TOWN OF CHAPIN
Architectural Review Board Rescheduled Regular Meeting
Council Chambers, Chapin Town Hall
June 11, 2025
6:00 PM

To: Architectural Review Board
From: R. Radtke, Planning & Zoning Manager
Date: May 30, 2025
Re: Lake Murray Pediatric Dentistry

Property Location: 740 Old Lexington
Tax Map Number: **000700-07-062**
Property Zoning District: Office Commercial (OC)
Property Overlay District: Craftsman
Applicant: Craig Otto
Zoning Permit: 24-11-14-001

Lake Murray Pediatric Dentistry

Seal	Date MAY 12, 2025
	Drawn By OTTO
	Drawing No. A2.1

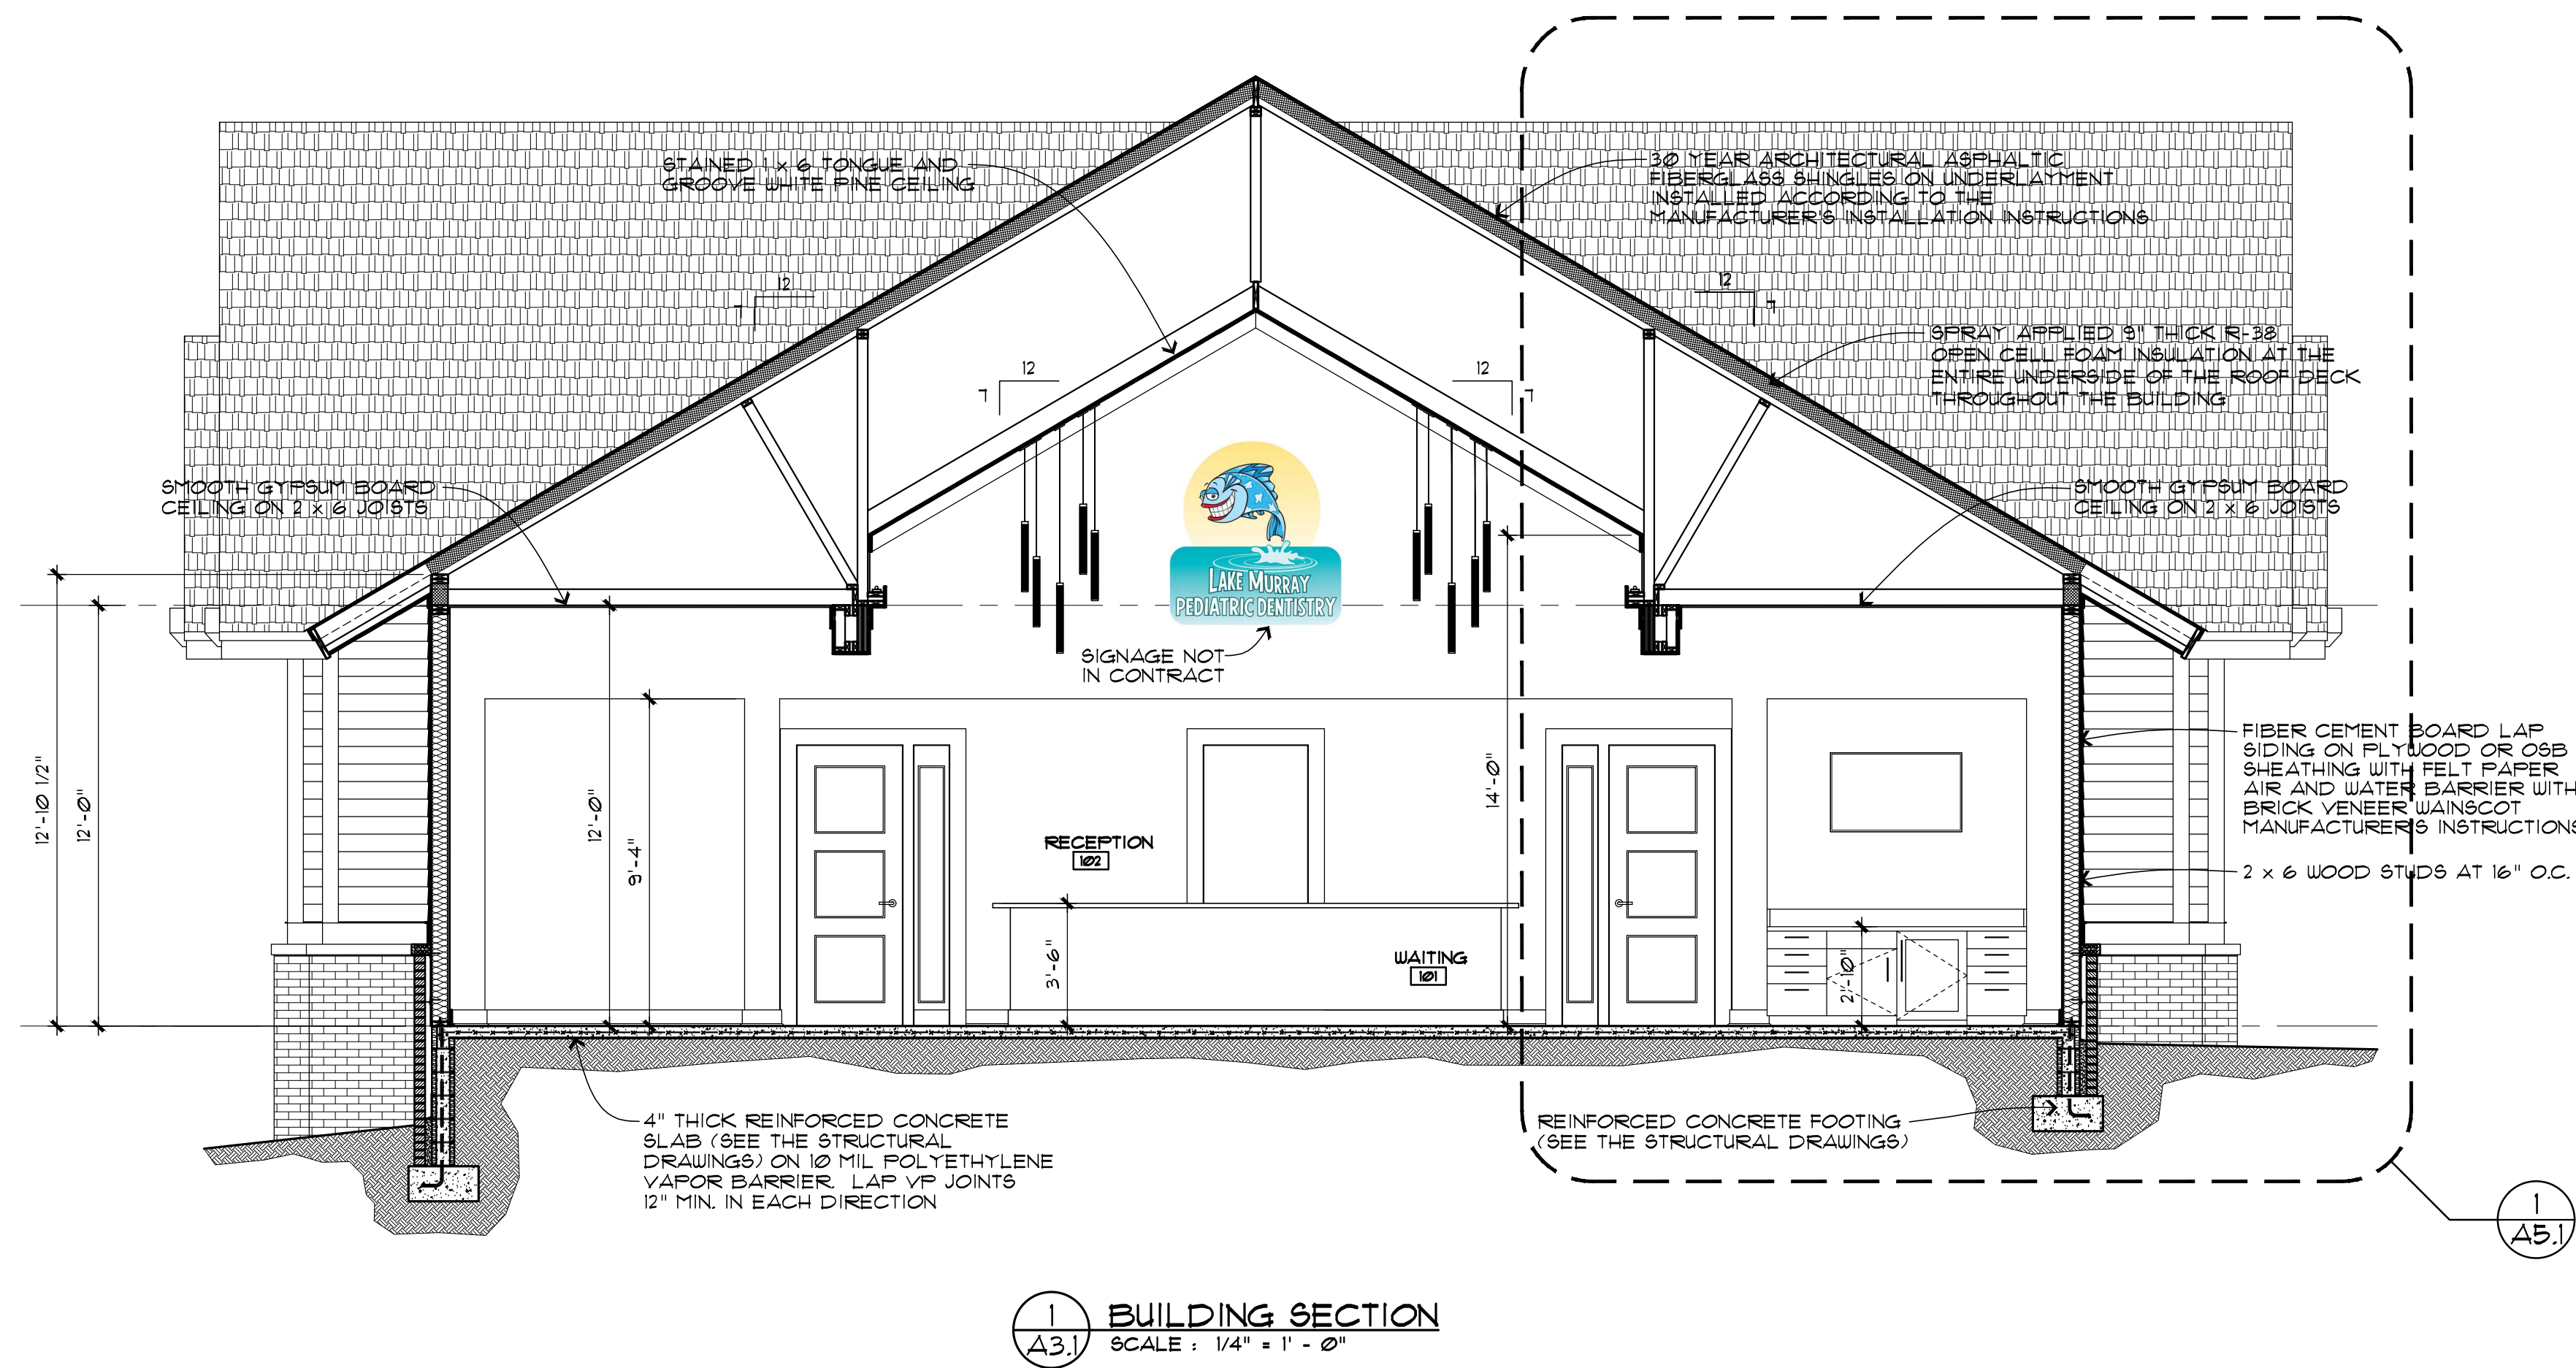
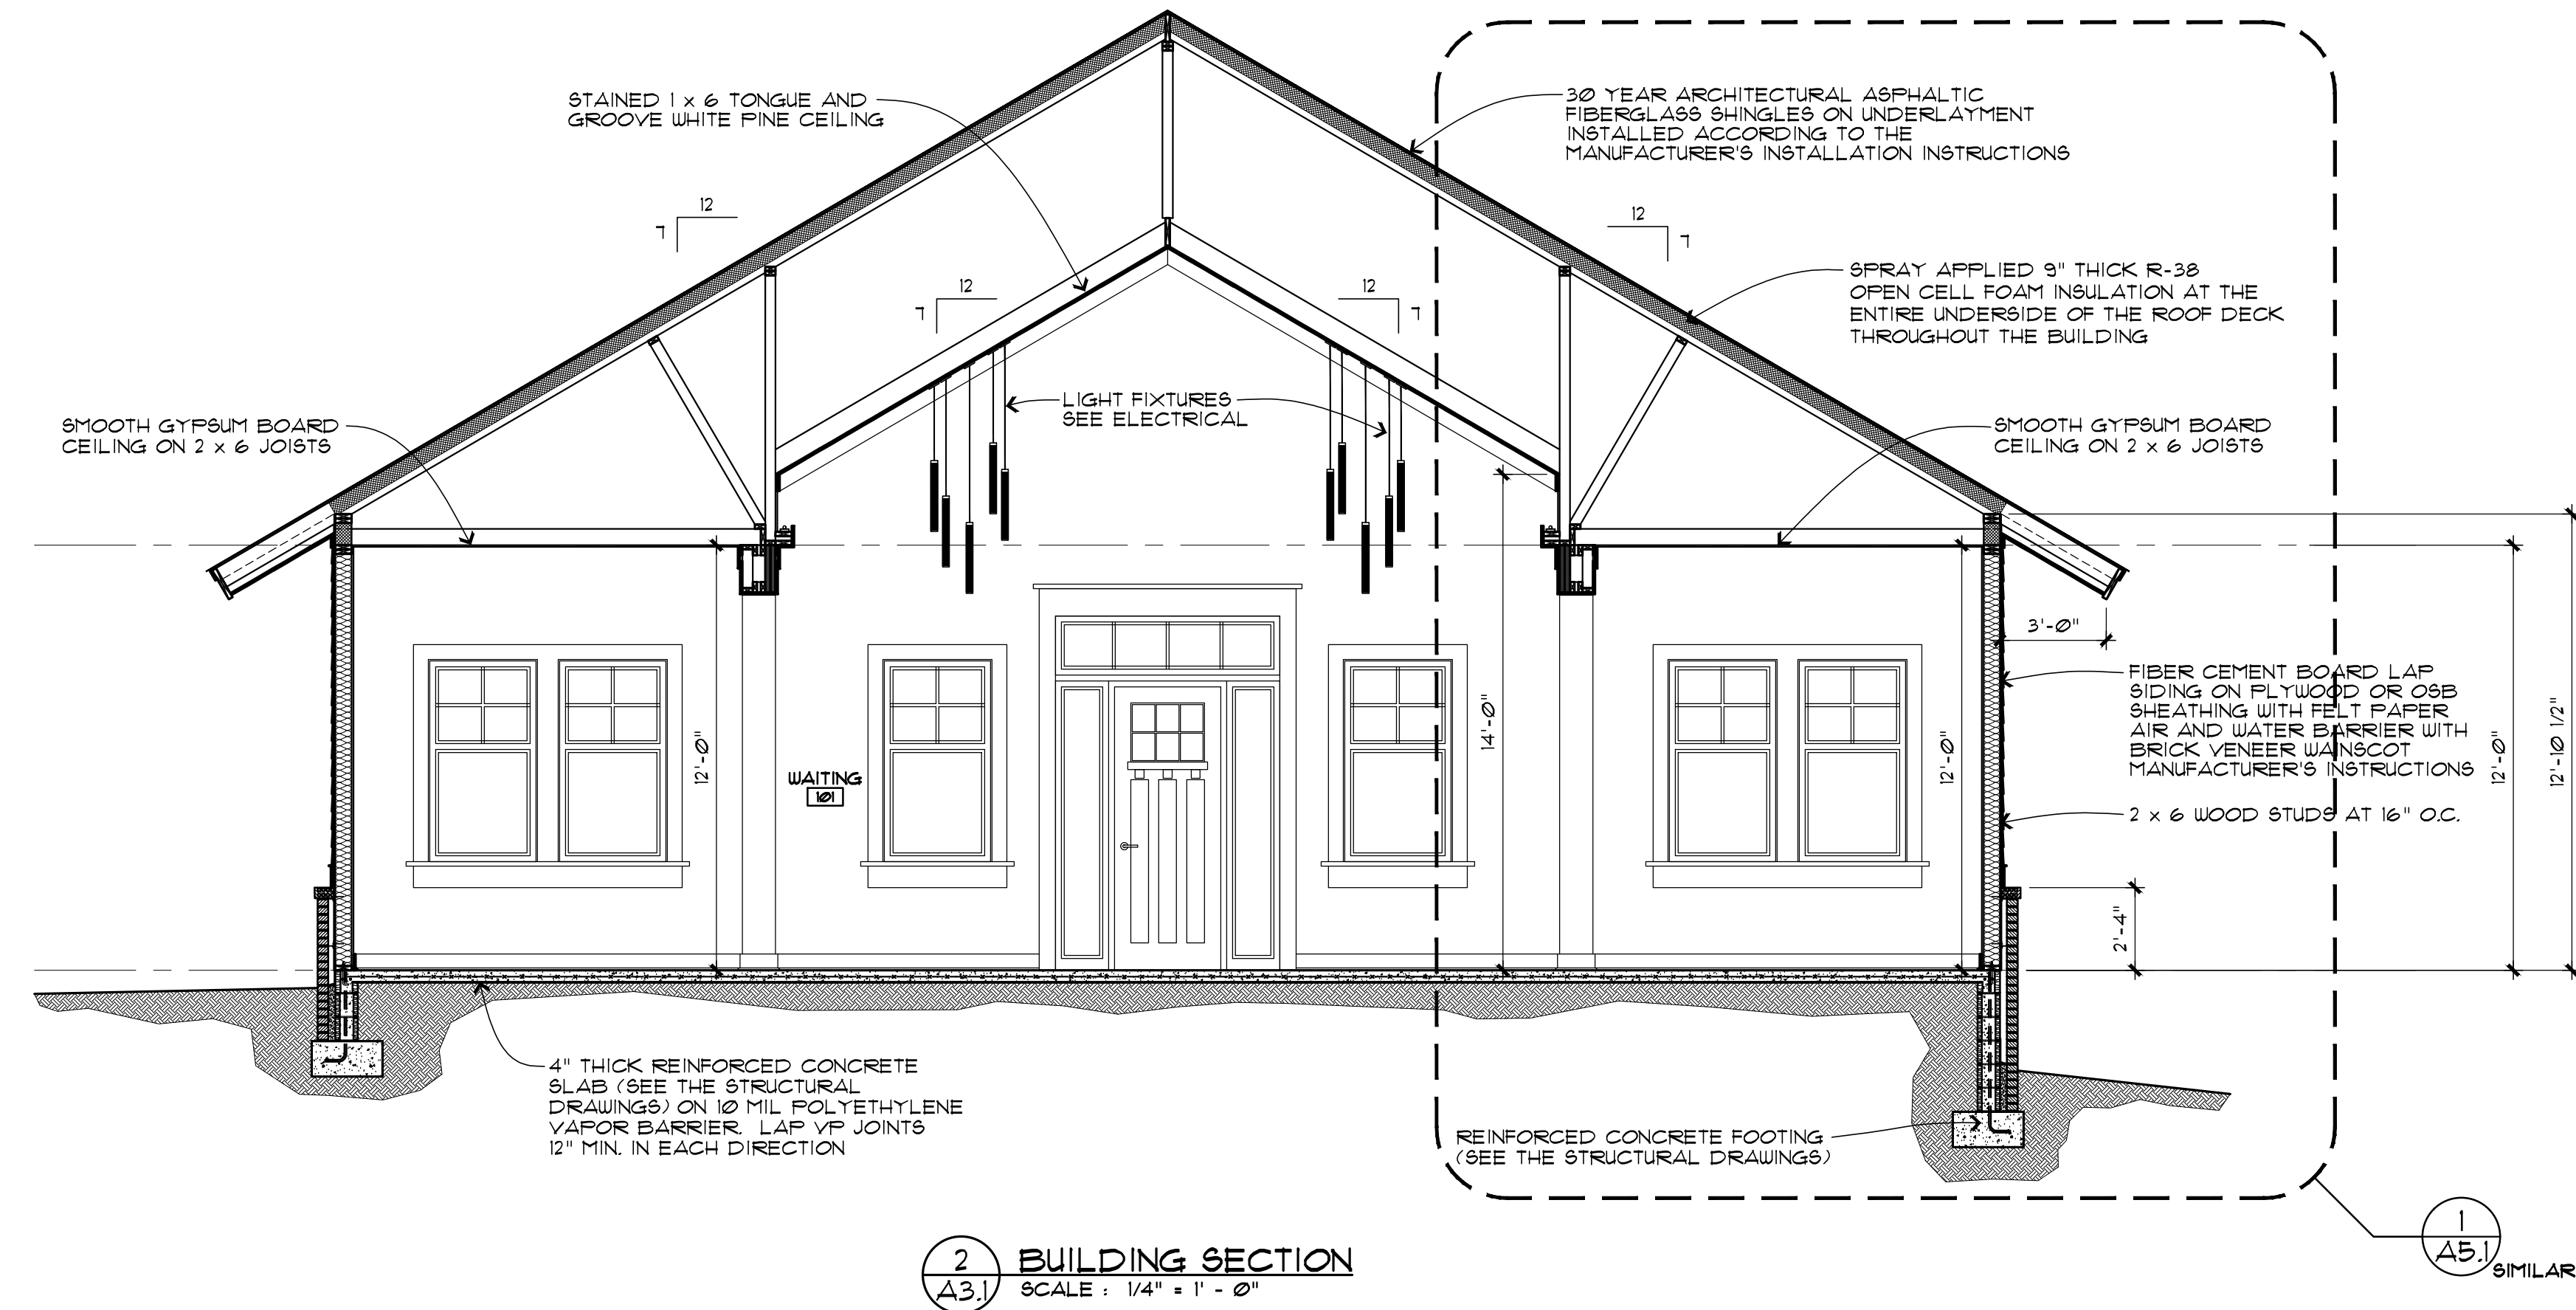
1. Revised A2.1 Plan – In compliance with exterior wall pack. Left side & rear only.
 2. Cut sheet provided for W fixture (very small) (see spec sheet)?
 3. Revised C1 Plan with Open space indicated.
 4. Clarification needed with tree survey.
- The material used to be aesthetically pleasing and harmonious with the existing building. Recommendation from ARB with unique color and exterior materials to match building.
